Agenda – Assiniboia Community Committee – January 6, 2026

Item No. 6 Variance – Country Meadow Boulevard (Waverley West Ward) File DAV 241968/2025D

Title: DAV 25-241968\D – Country Meadow Blvd

Issue: For consideration of Variances associated with landscaping requirements and parking requirements.

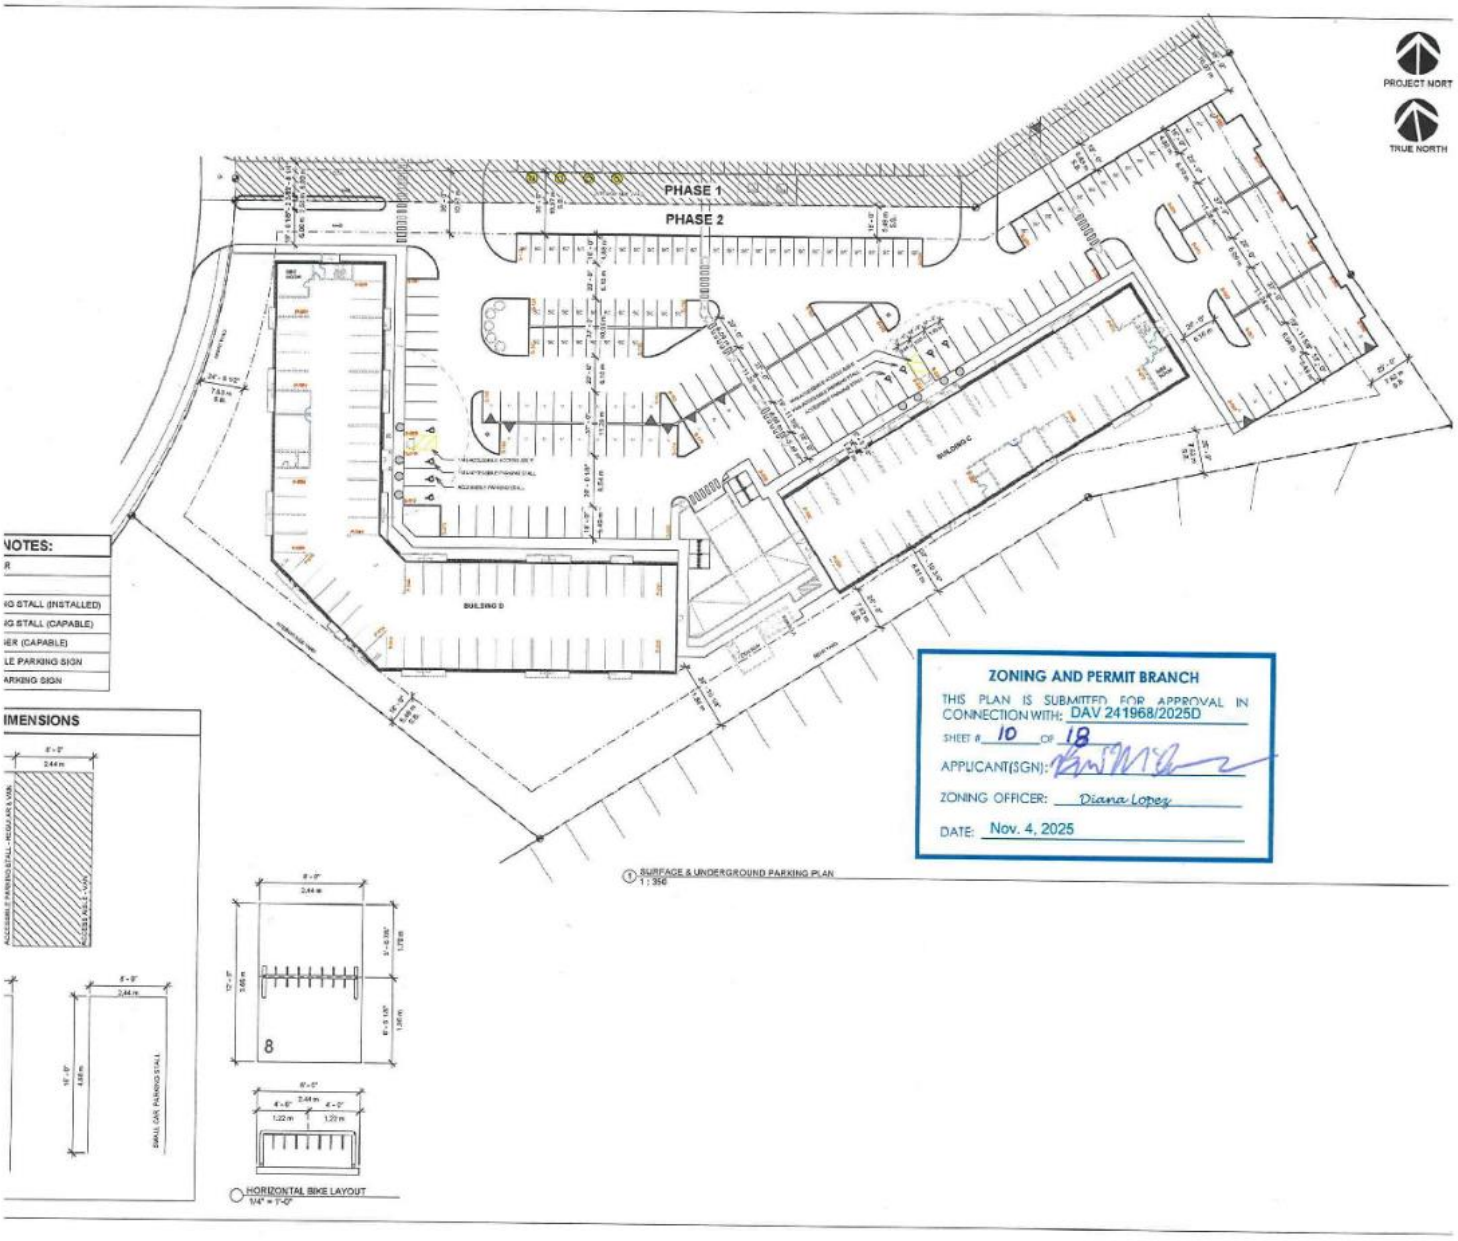
The Winnipeg Zoning By-law requires 1.5 stalls per dwelling unit in Recent Communities. The applicant is proposing 265 parking spaces (1.32 ratio) per dwelling unit for Lot 1 and 275 spaces (1.27 ratio) for Lot 2.

- Lot 1 has a proposed parking ratio of 1.32, while Lot 2 has a ratio of 1.27. Combined, they have a ratio of 1.3. A ratio of 1.5 for each site is required.
- Broadstreet Properties has provided evidence showing their properties have a parking stalls used to occupied unit rate of 0.83 to 1.25, with an average of 1.01.
- The application includes 328 bicycle parking stalls between the four buildings, which is significantly higher than the 63 required stalls.
- 64 of the proposed bicycle stalls are short-term outdoor stalls, while the rest are secured and weather protected stalls.
- Secured bicycle stalls are being provided at a rate of 0.39 per unit, and bicycle stalls as a whole are being provided at a rate of .55 per unit.
- The provided evidence and increased bicycle parking stalls combine to allow for an acceptable parking ratio of 1.3 between the two buildings.

- Both Lots 1 and 2 are required to have 16 trees and 86 shrubs along the property line between the two Lots, for a total of 32 trees and 172 shrubs.
- The location of the required variances is at the property line between the two lots.

- The property line runs through the middle of the parking lot servicing all four buildings.
- The lack of landscaping is due to the property line not functioning as a barrier between properties, but rather a continuation of the site.

- Lot 2 has no proposed front yard along Kenaston Boulevard, where 25 feet is required.
- The variance is only required for the corner of one parking stall, otherwise the requirement is met.
- The property line is approximately 224 feet from Kenaston Boulevard.
- Given the small variance required, and the distance from Kenaston Boulevard, the variance is supportable.

- The landscaping requirements of the property line can be relocated elsewhere on the properties.
- Landscaping is required for both properties along the same property line where the proposed variance is located. The Urban Planning and Design Division recommends a condition that allows for the landscaping requirements for one side to be dropped, and the other side to be located elsewhere on the edge of the property.

- For one property edge, the landscaping requirements are 1 tree per 35 linear feet, and 3 shrubs per 20 linear feet. This gives a requirement of 16 trees and 86 shrubs, which will be required to be located elsewhere.

- That a minimum of 328 bicycle stalls, with at least 265 of those stalls being secured stalls, be provided across the four buildings.

- That, in addition to what is required, a minimum of an additional 16 trees and 86 shrubs are planted in other areas of the development, to the satisfaction of the Director of Planning and Property Development.
